# ADMINISTRATIVE AMENDMENT

**ABQ**  
 uptown  
 DRB Submittal  
 Site Development Plan for Building Permit  
 Site Plan 01 of 14  
 23 June 2004  
 Project #1002247

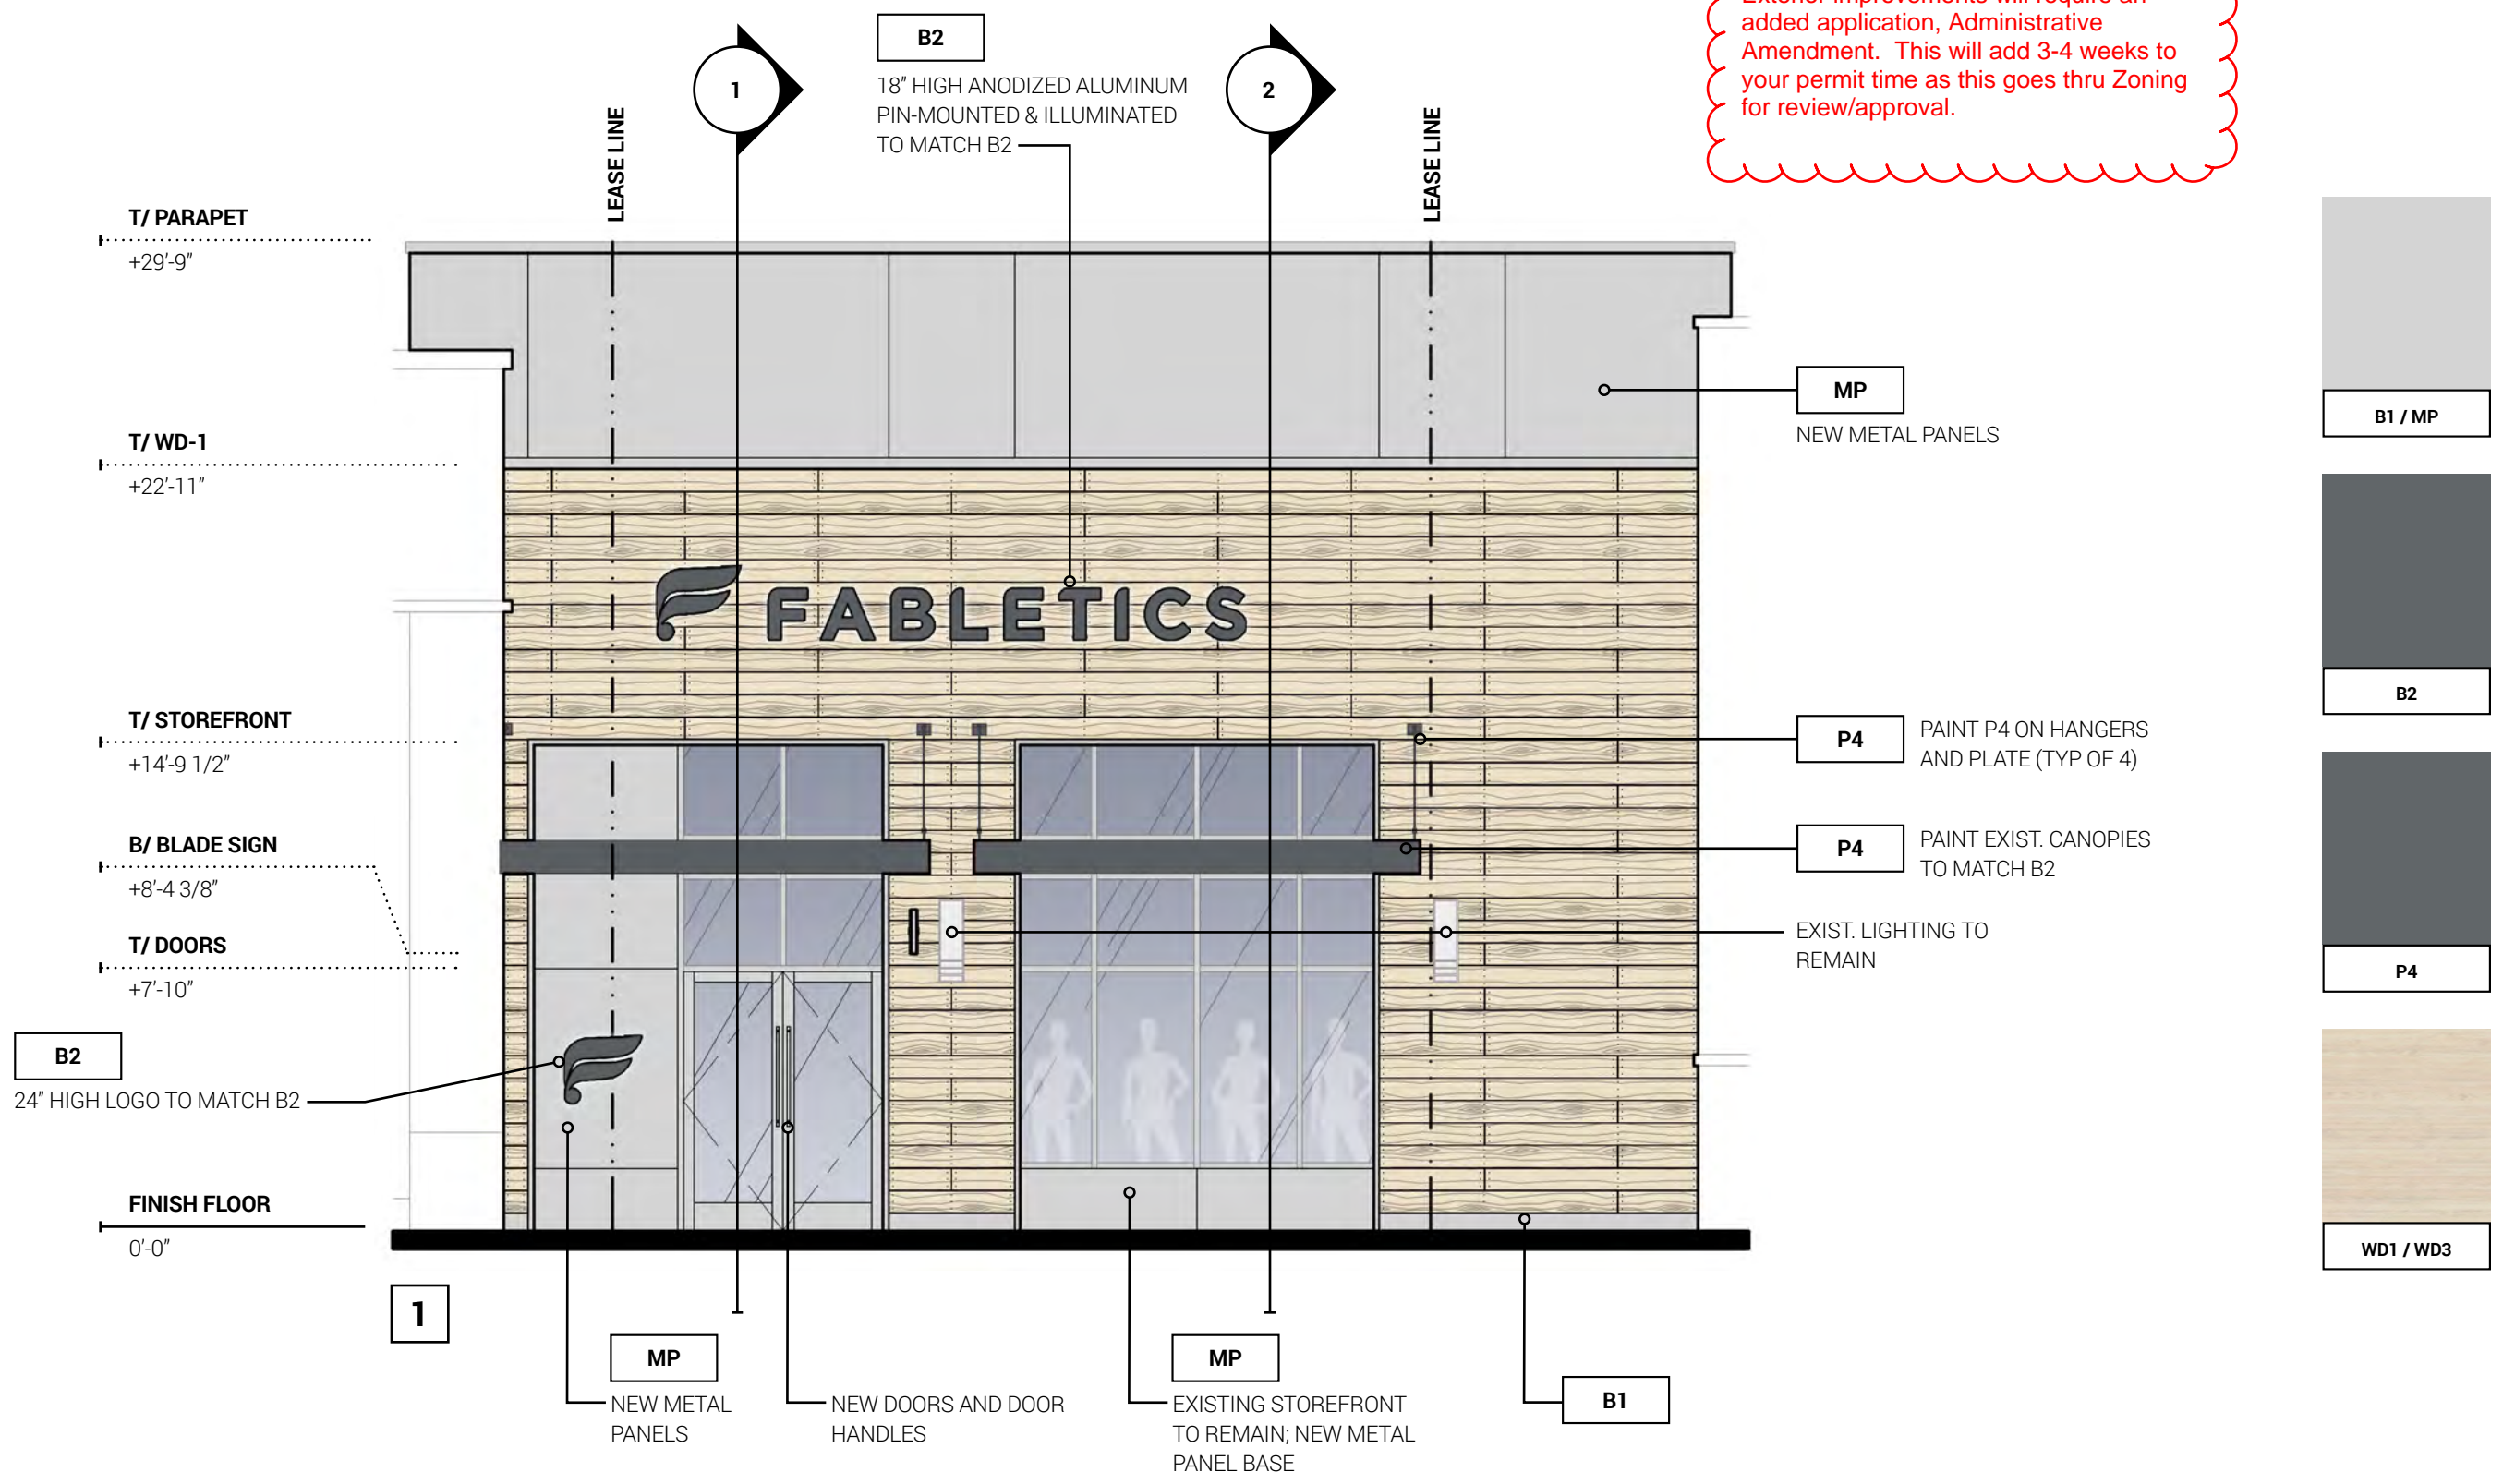
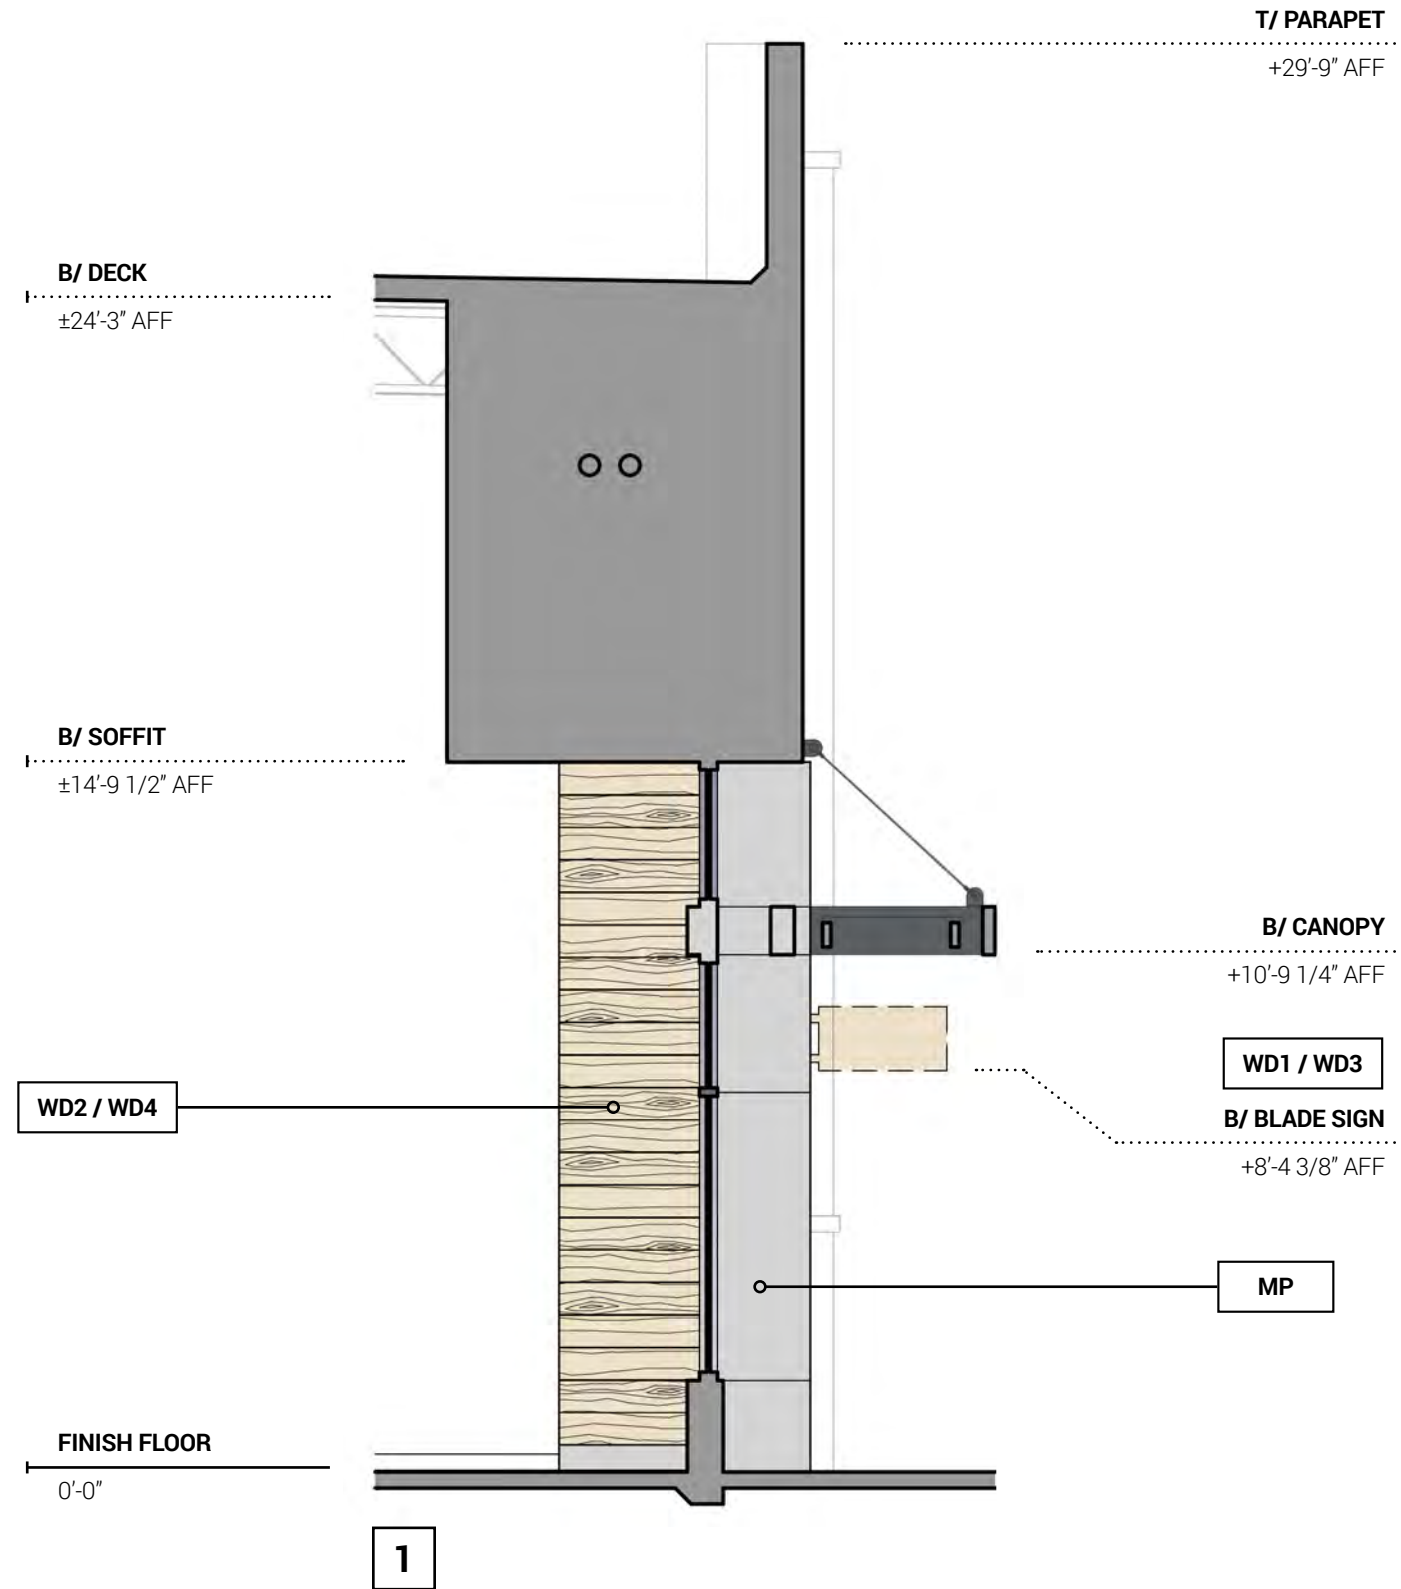
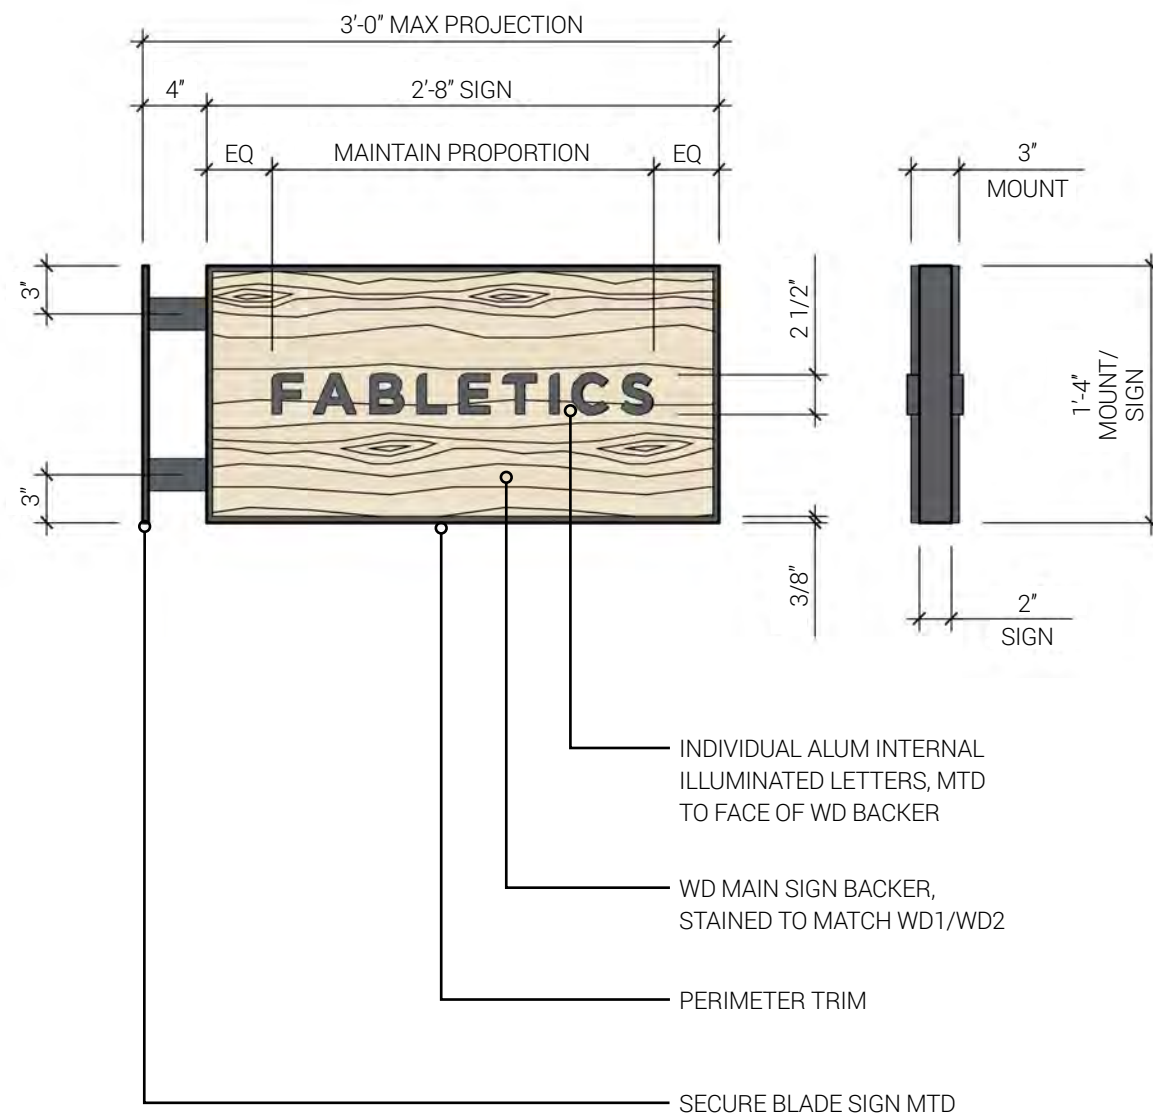
LL Comment (CMS):  
 Exterior improvements will require an added application, Administrative Amendment. This will add 3-4 weeks to your permit time as this goes thru Zoning for review/approval.
